## 3.0 COMMENTS ON THE DRAFT EIR AND RESPONSES TO COMMENTS

Subject: CSU East Bay Hayward Campus Master Plan  
SCH#: 2008042100

**California State University East Bay Hayward Campus Master Plan – Draft  
 Environmental Impact Report**

FIGURE 3.0-1

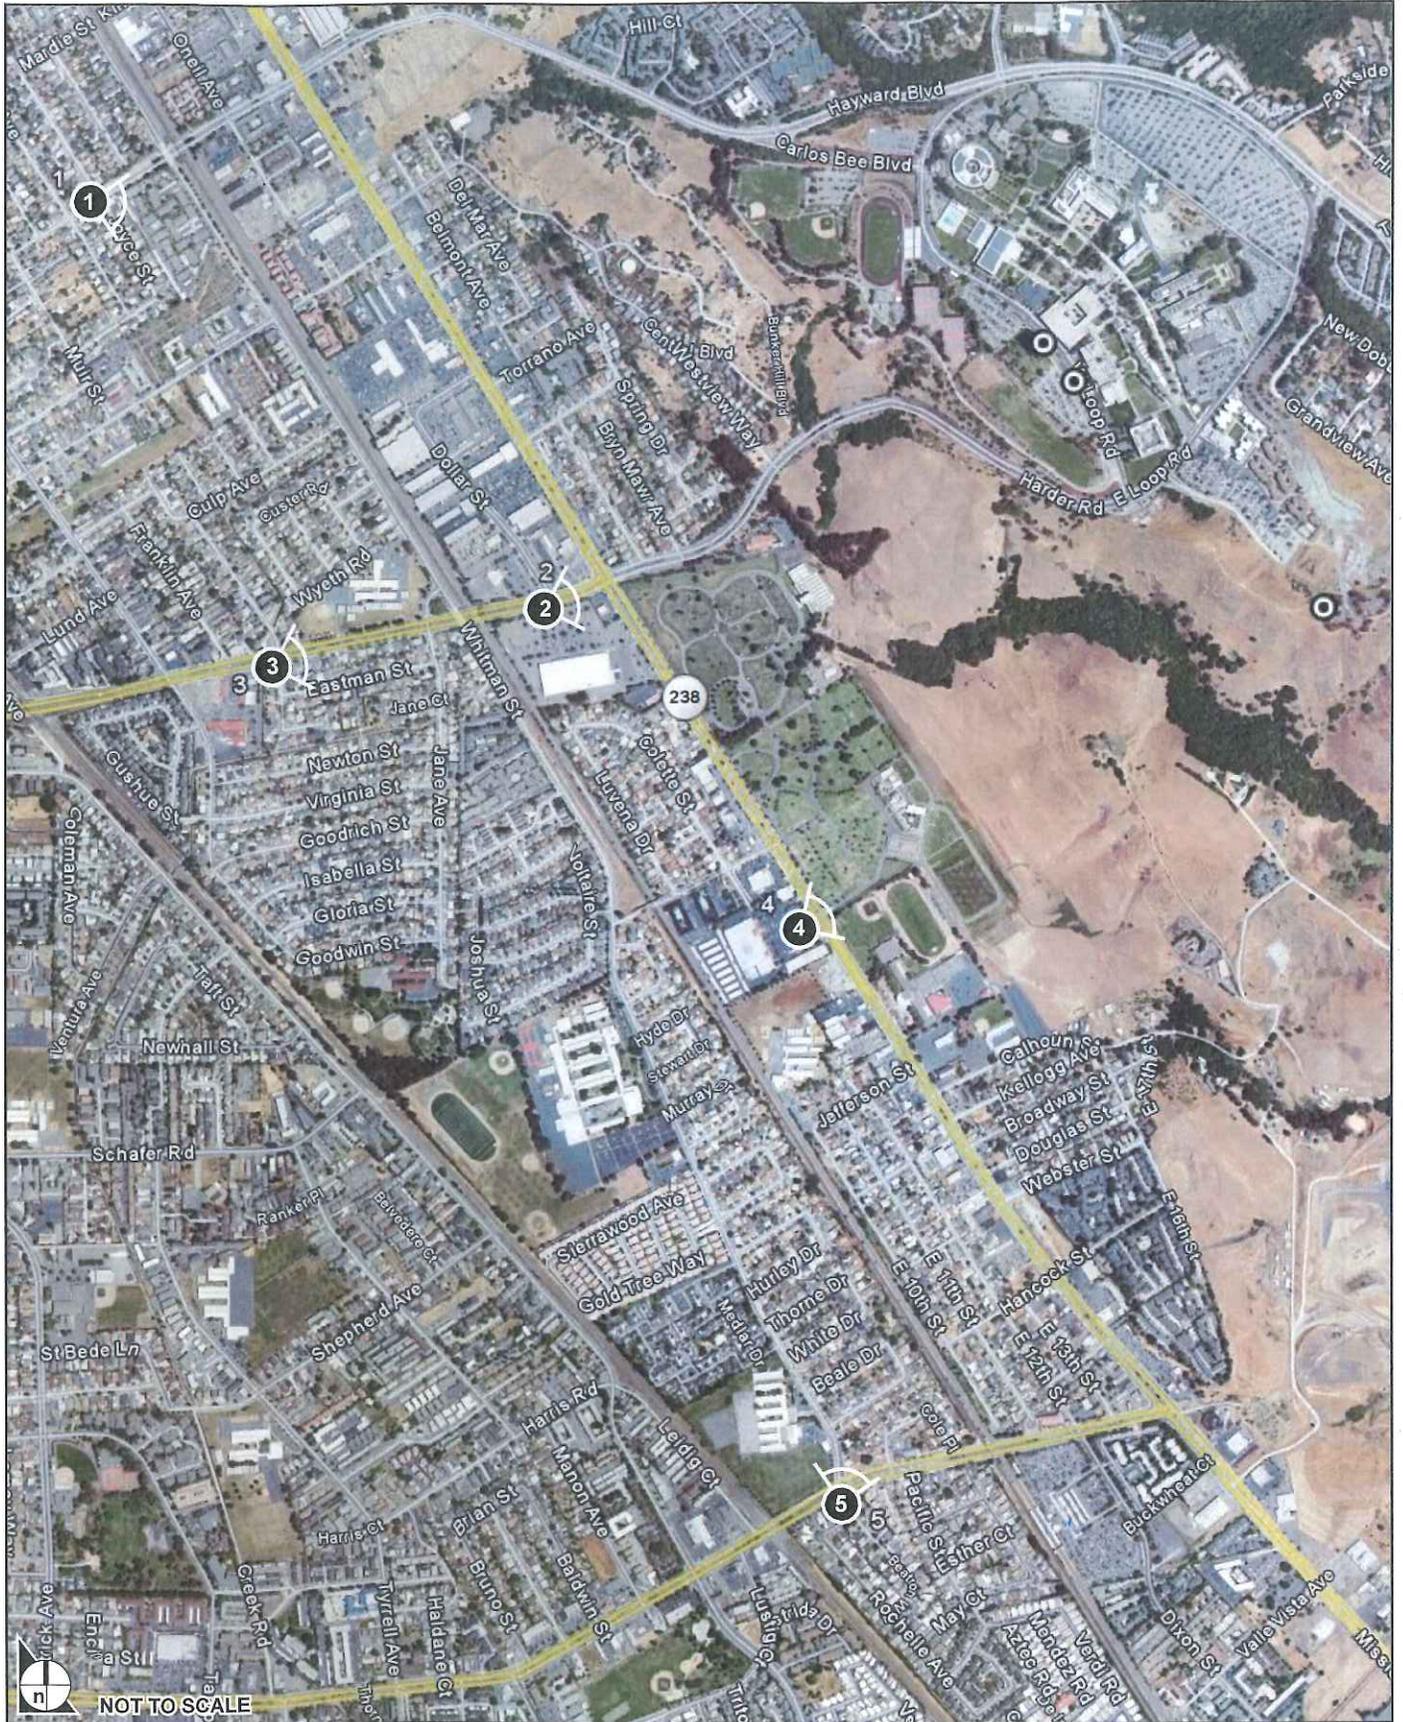
2. **Volume II – Aesthetics – Section 3.4.1: The selection of the photo simulation vantage point along Harder Road (figure 3.0-4) does not represent a simulation to allow the reader to adequately assess the impacts of the proposed parking garage at Harder Road and West Loop Road. A vantage point further downhill towards the west from a public vantage point, such as along a major public roadway or from a public park, should be included to allow a more adequate evaluation of the visual impacts of the five levels of parking garage as viewed from the west.**

but they do not reflect exactly how the campus will look in the future. However, because the City requested visual simulations be prepared to show the changes in the views of the campus as viewed from the west, additional visual simulations of the campus were prepared based on the illustrative plan. Vantage points to the northwest, west and southwest of the campus were selected for this purpose. Locations close to the campus and further out from the campus were selected (see **Figure 3.0-1**).

FIGURE 3.0-8

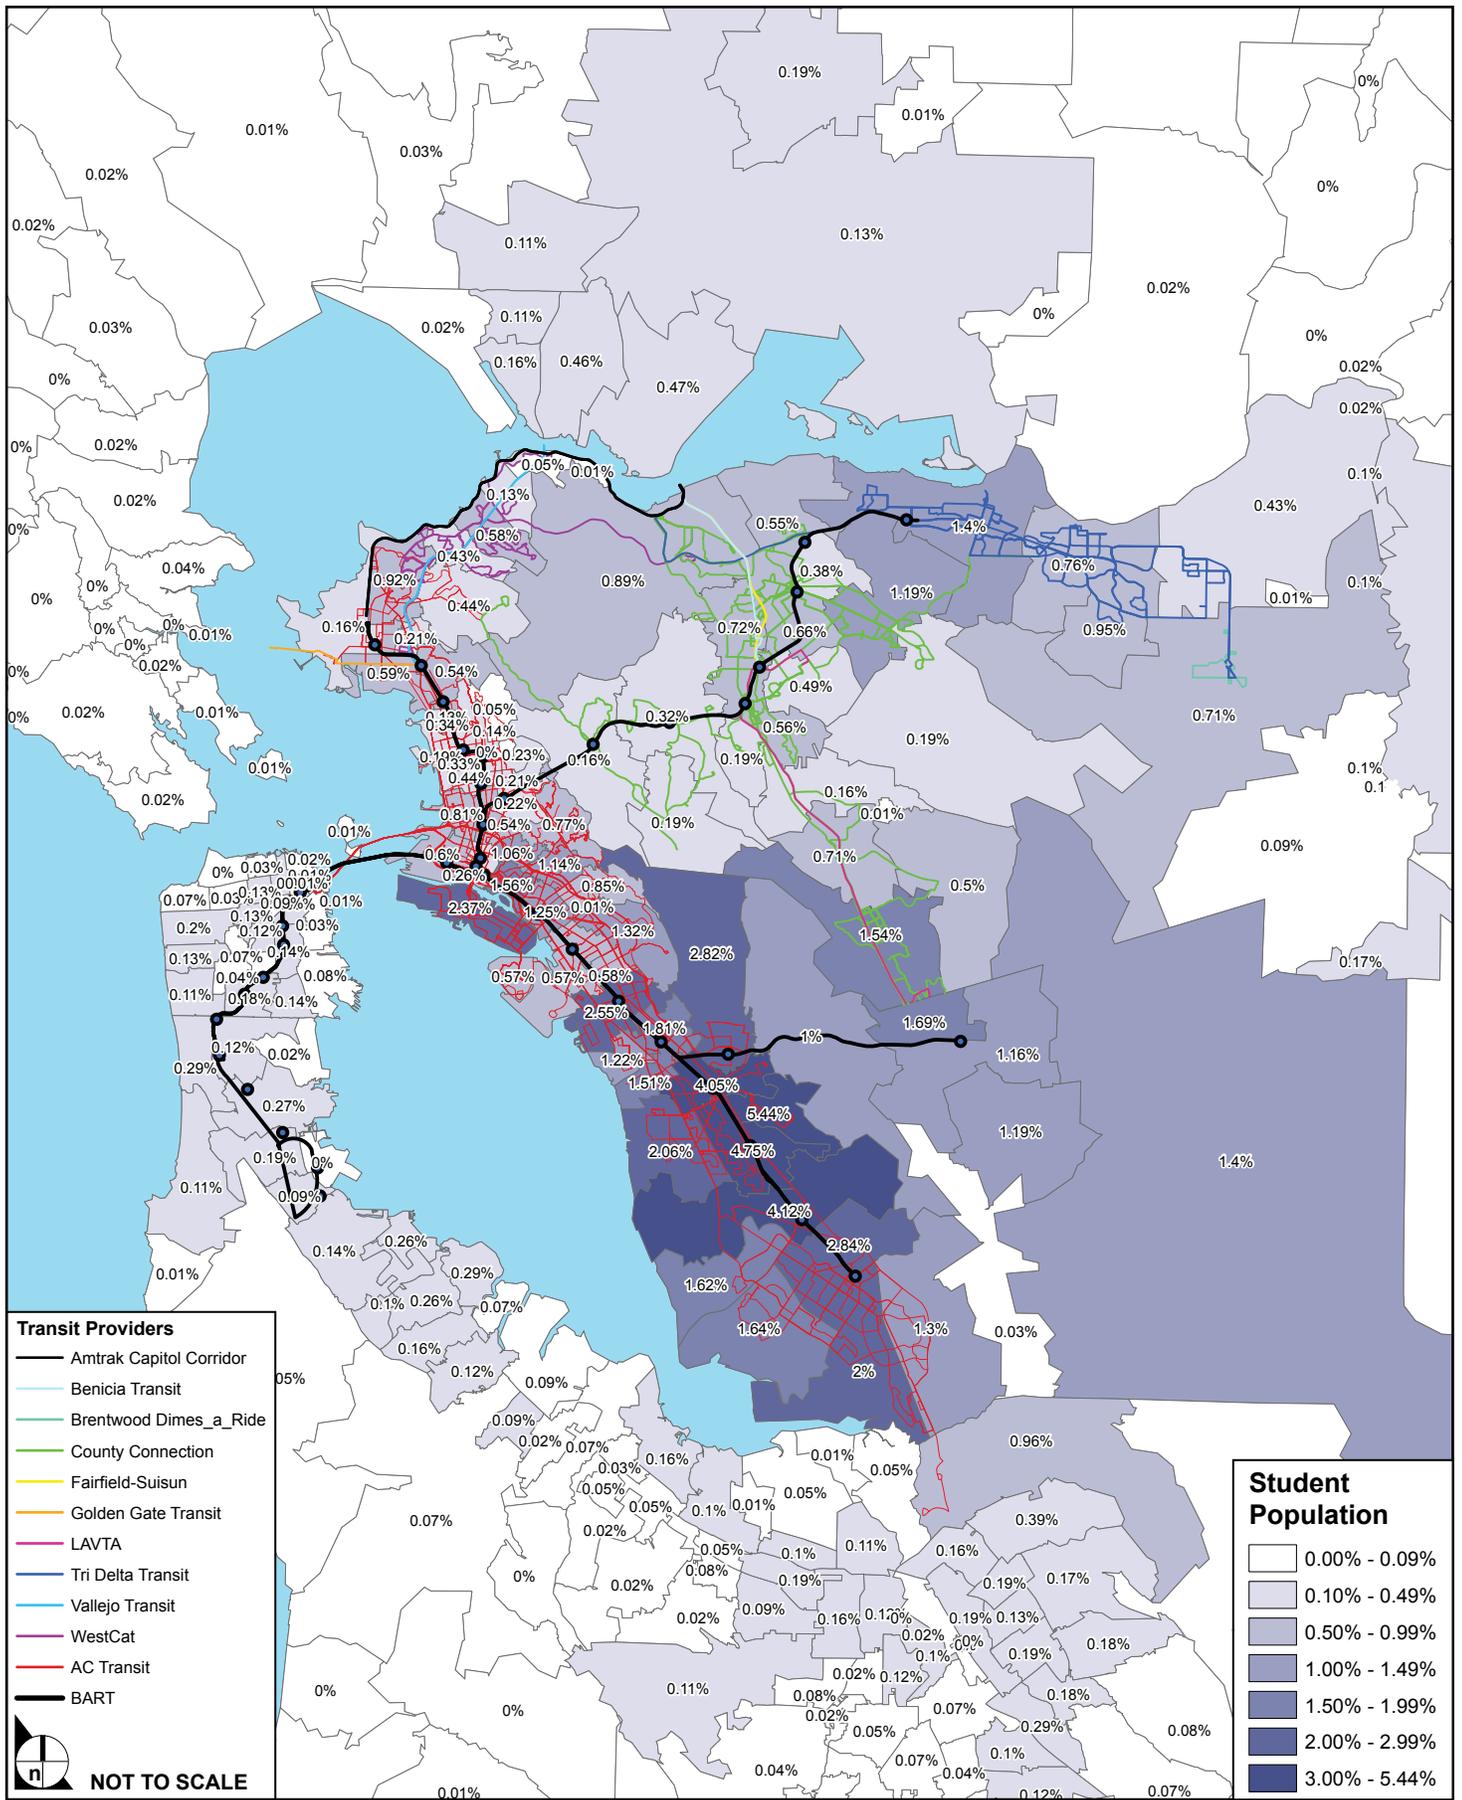
It would be helpful if Cal State East Bay (CSU) can illustrate where their students/staff are coming from within Alameda County and how that relates to transit demand. Based on Figure 4.12-6 (Trip Distribution), it looks like about 40% of all trips come from the south. If this is correct, Figure 4.12-6 seems to contradict the "reverse commute" assertion in the text and BART line trip distribution outlined in Table 4.12-12.

Student zip code data were used to determine the directional distribution of potential BART riders (see **Figure 3.0-8, Student Distribution by Zip Code**). It differs from the project vehicle trip distribution, which was based on the ACCMA travel demand model. The student residence data is considered the more accurate source for the distribution of potential BART ridership, whereas the travel demand model is considered the more accurate source of vehicle trip distribution and assignment, since it takes into account roadway network characteristics in addition to the origins of commuting students, faculty, and staff.
